Addendum No. 1
March 3, 2025

Project: Reroof Damaged Areas
South Dakota State University Student Union
Brookings, South Dakota
SDSU Project# 25-154440
OSE Project #R0325--12X/DEL
Architecture Incorporated Project #3099

Architect: Architecture Incorporated

ROOF PLAN

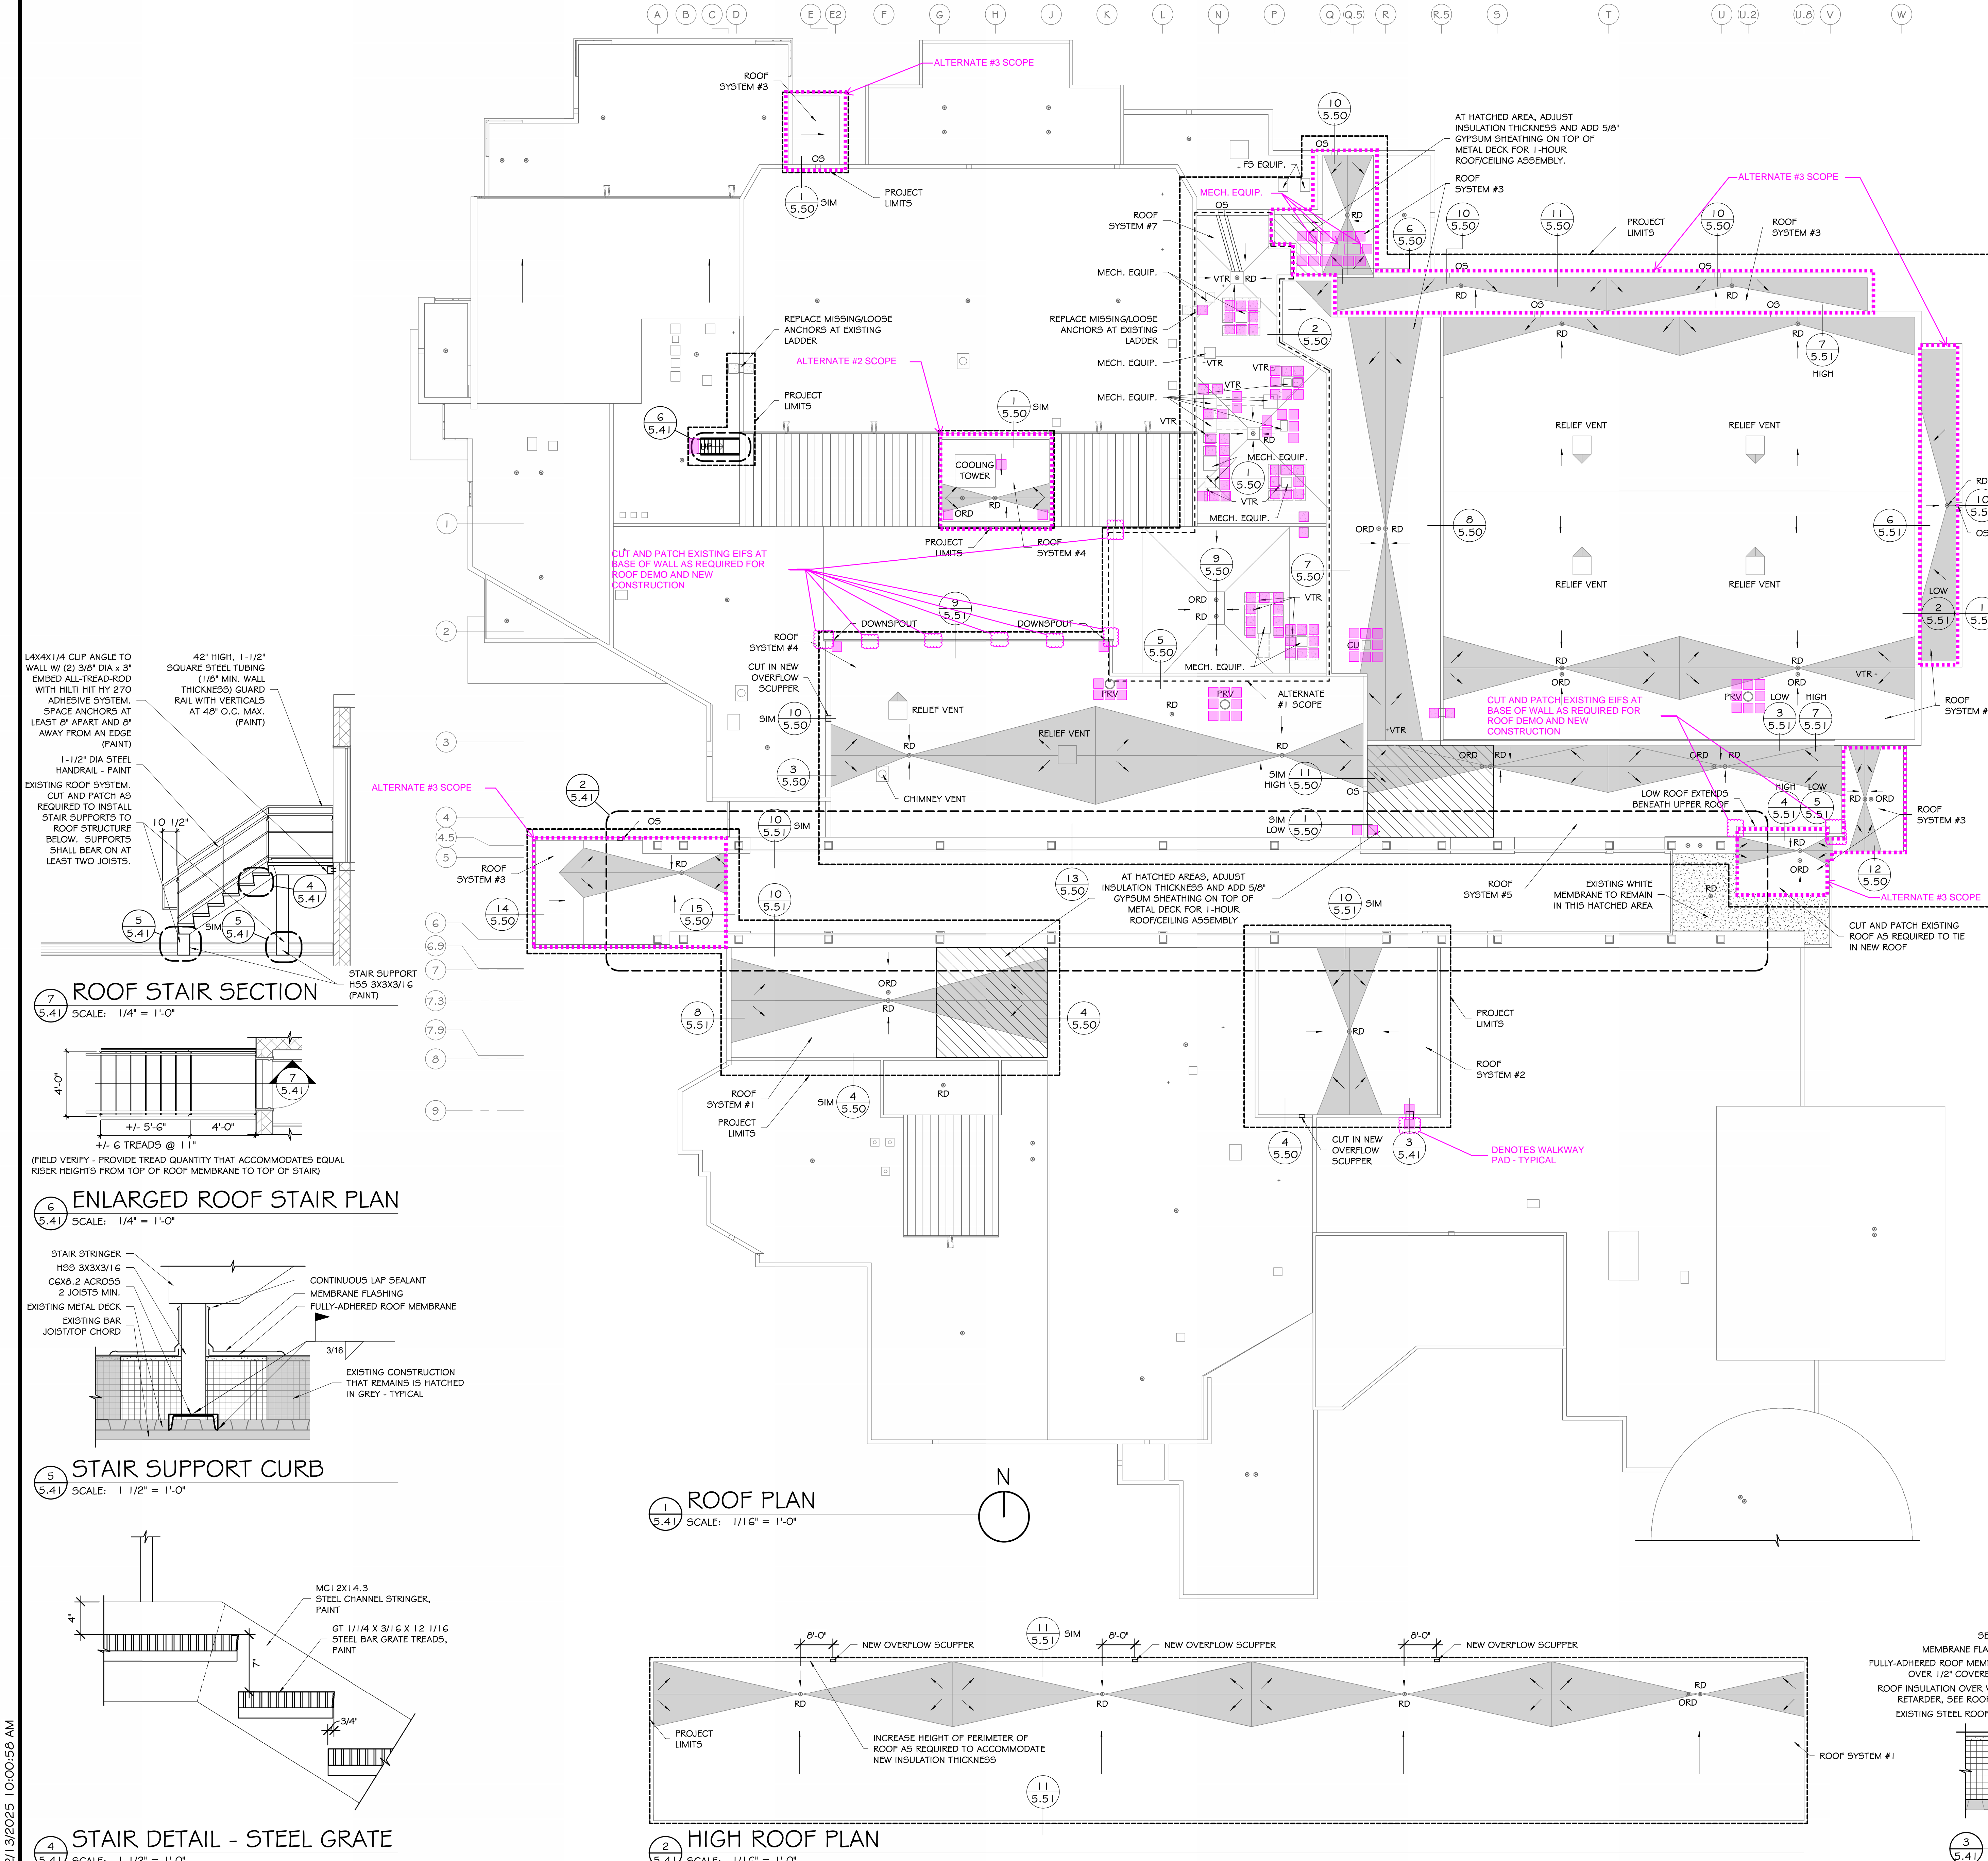
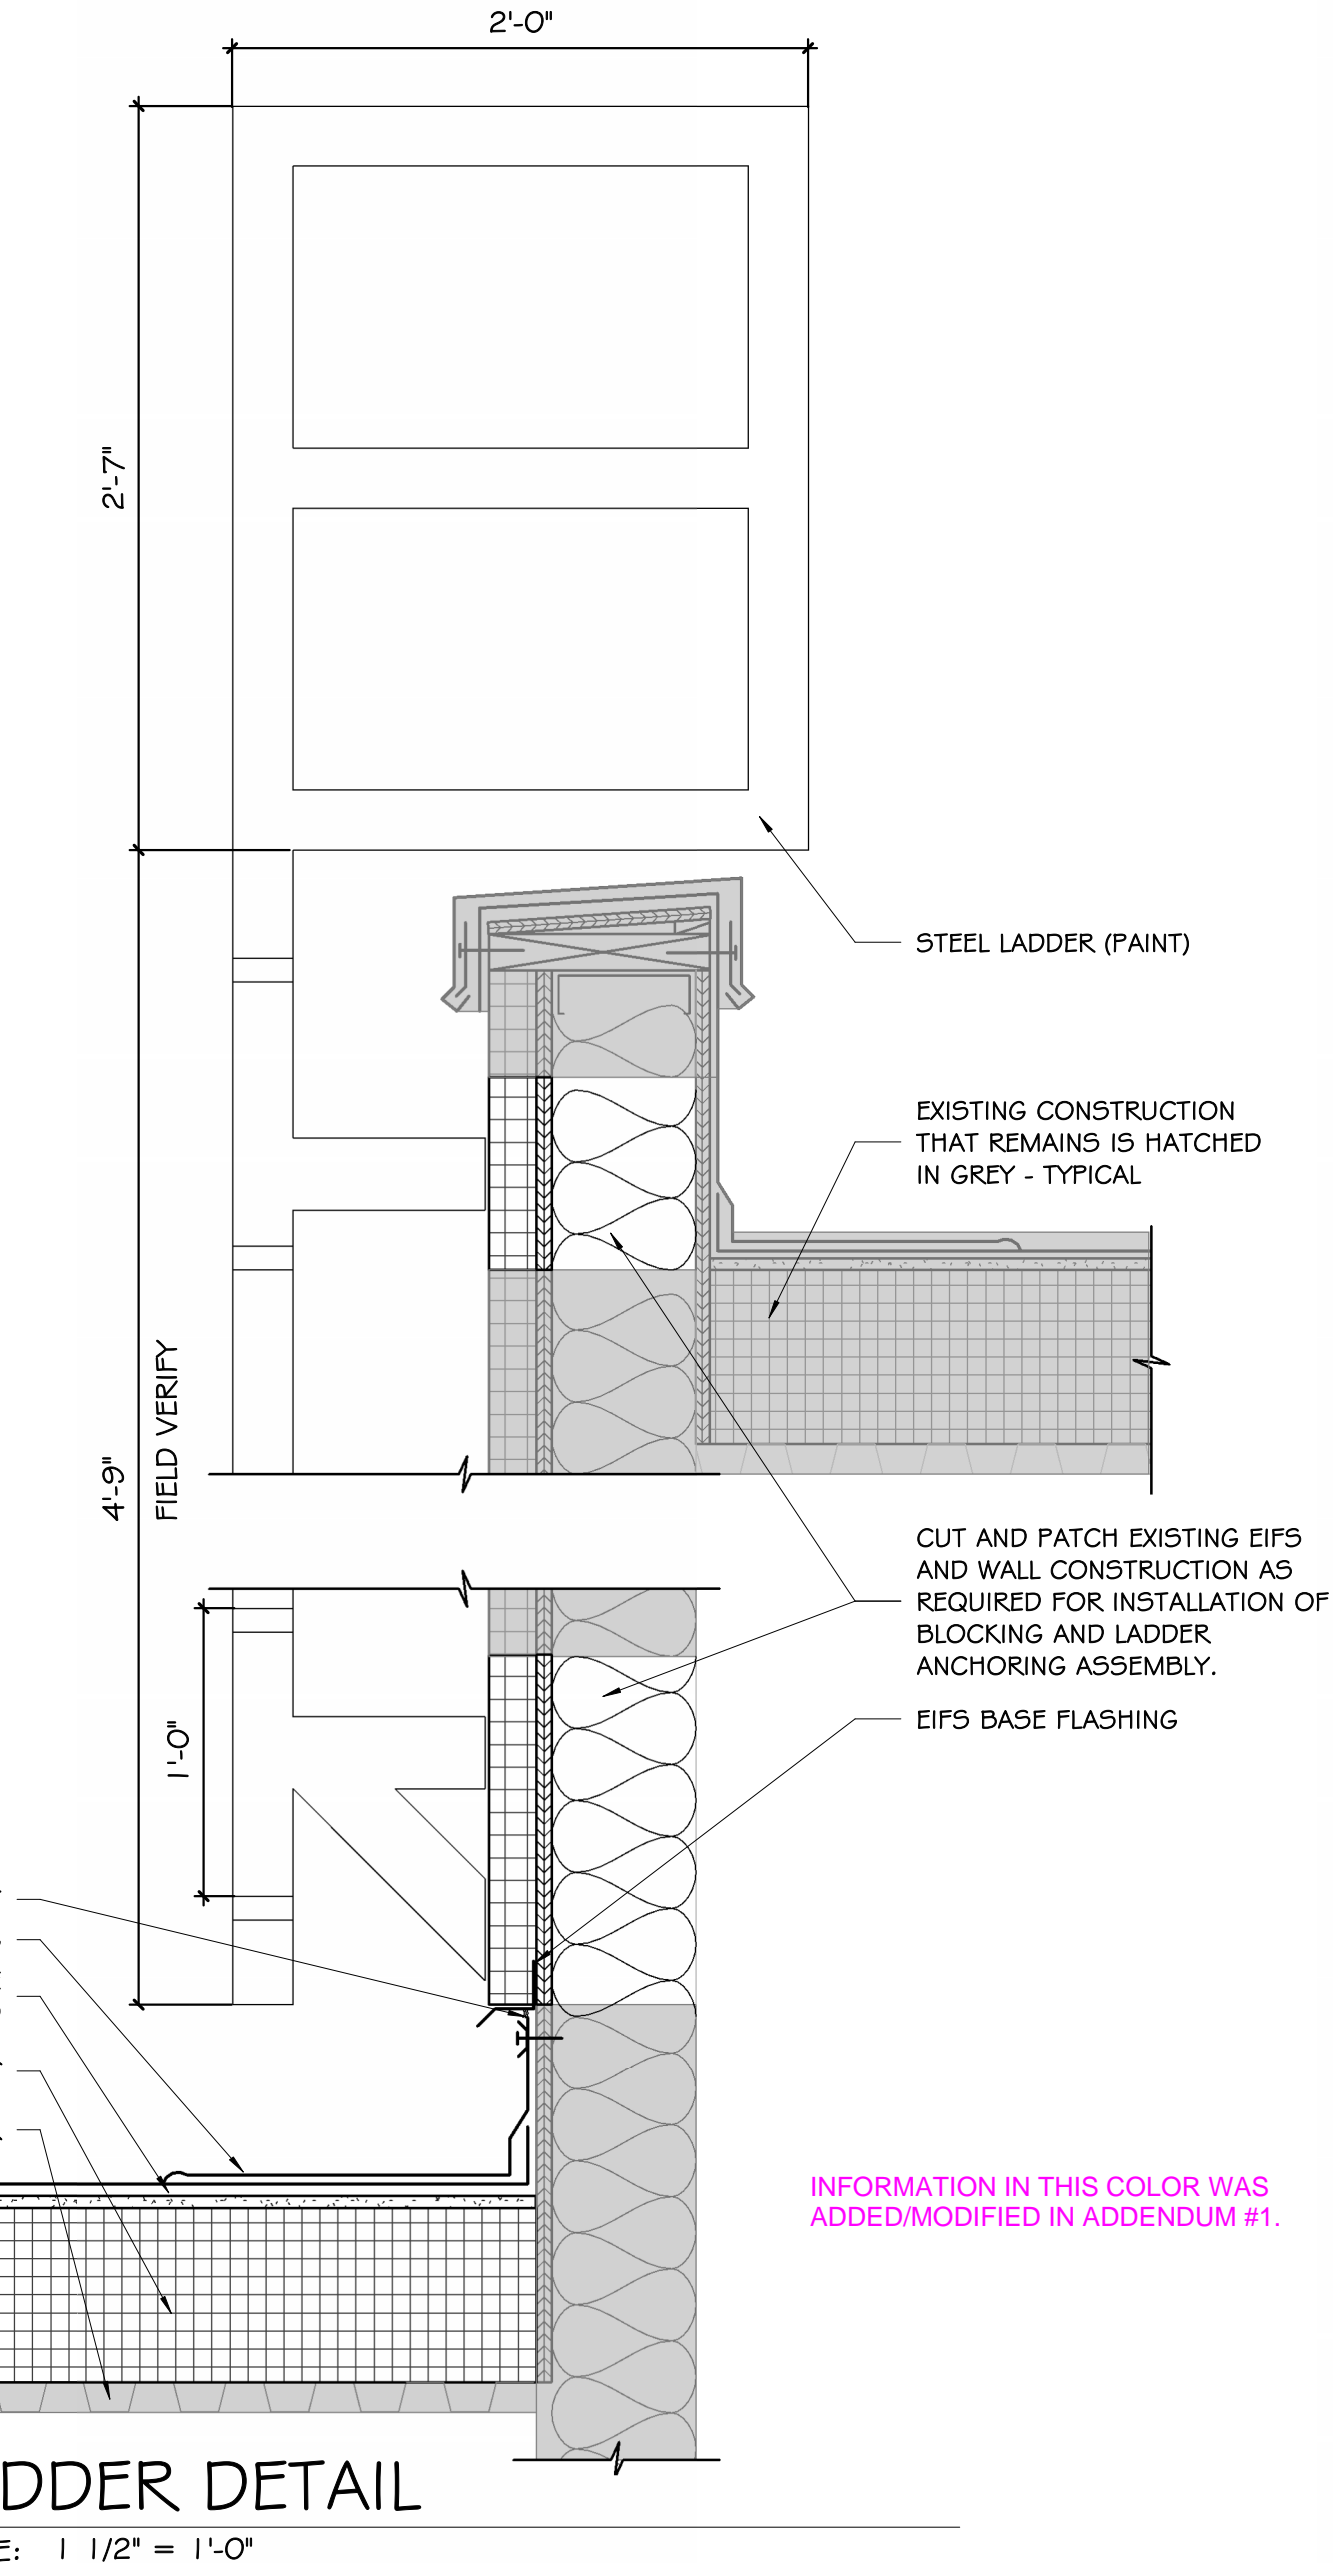
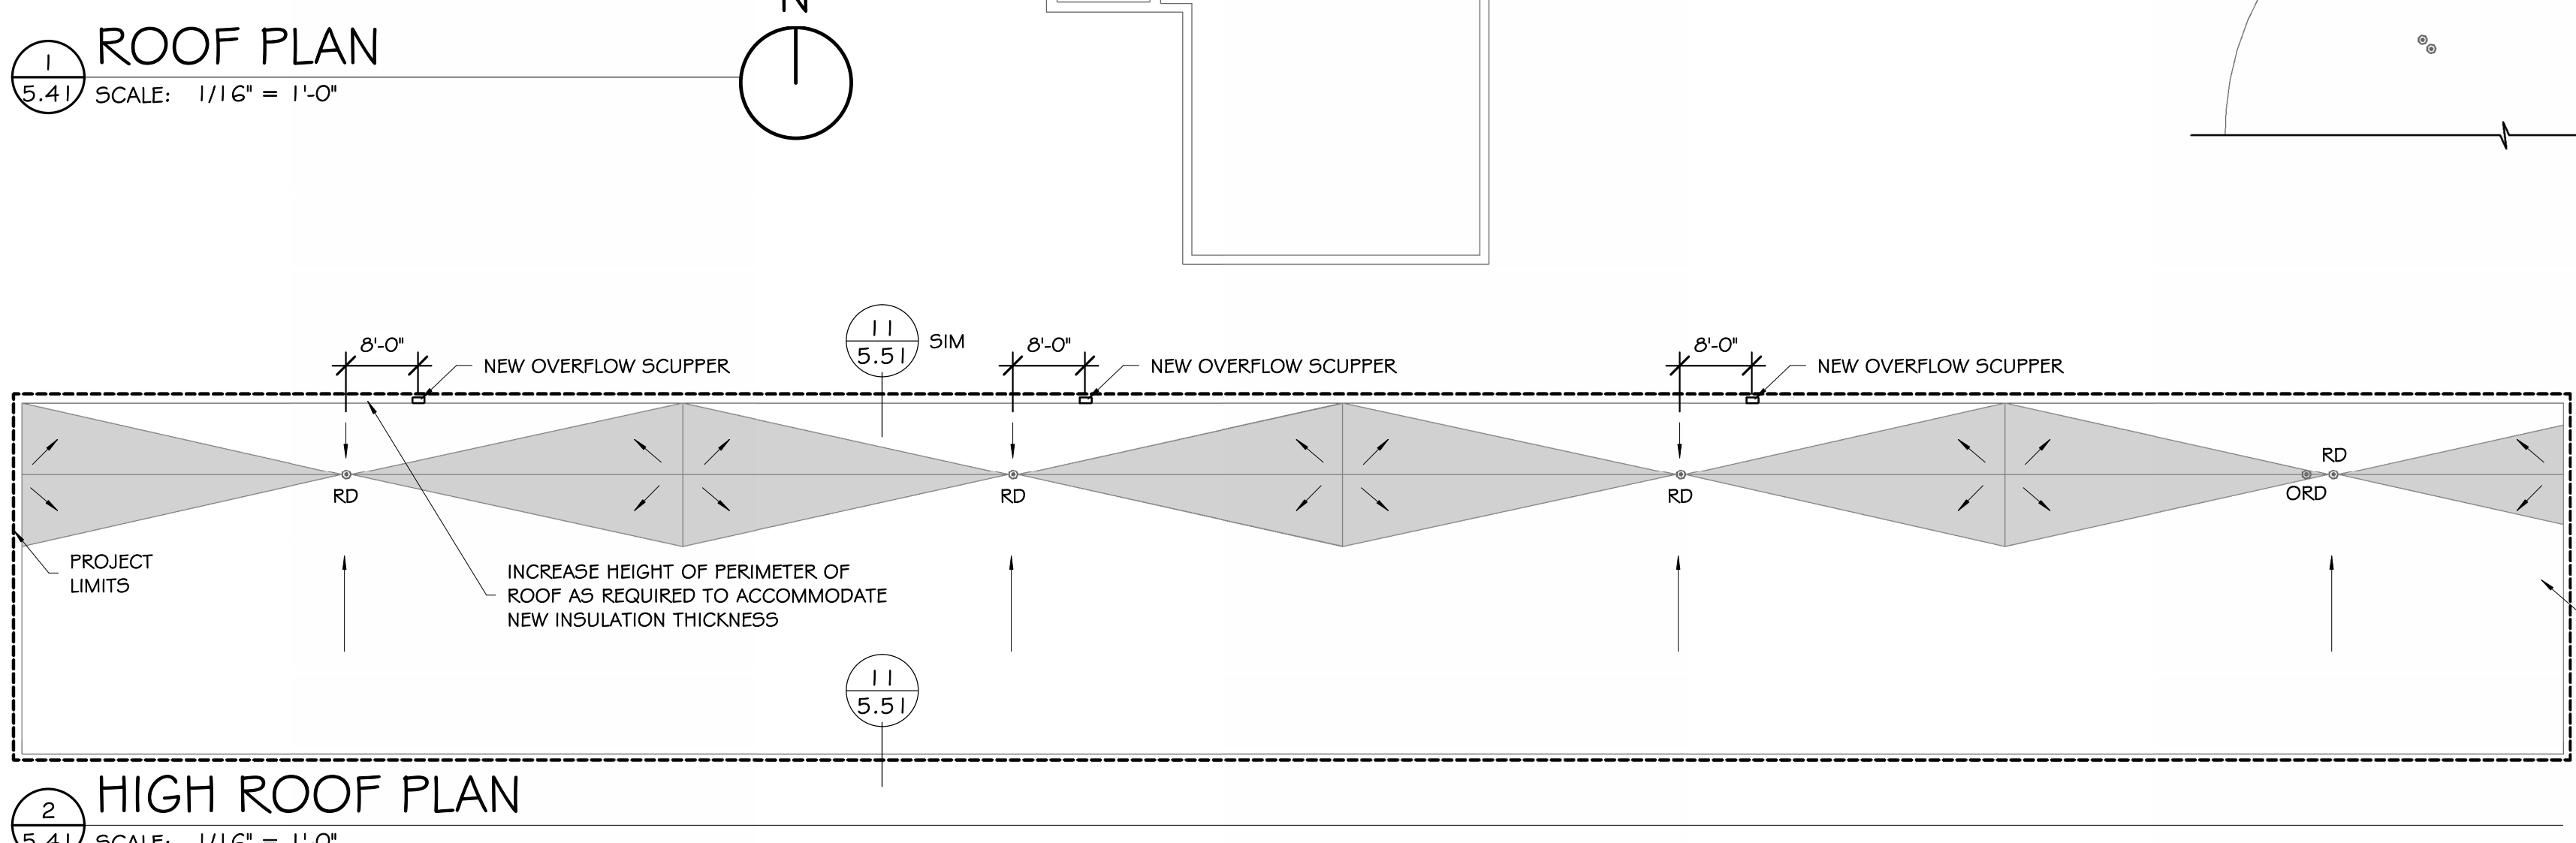
5) DRAWING SHEET 5.41 – ROOF PLAN

- a) Reference attached revised Drawing Sheet 5.41 for the following:
 - i) Base bid scope that has been changed to Alternate #2 and Alternate #3 scope.
 - ii) Added existing rooftop mechanical equipment at north side of the building.
 - iii) Added EPDM walkway pads around serviceable equipment, at the top & bottom of roof ladders/stairs, and at downspout discharge locations.
 - iv) Assumed locations of EIFS cutting & patching necessary to complete roof demolition and new construction.
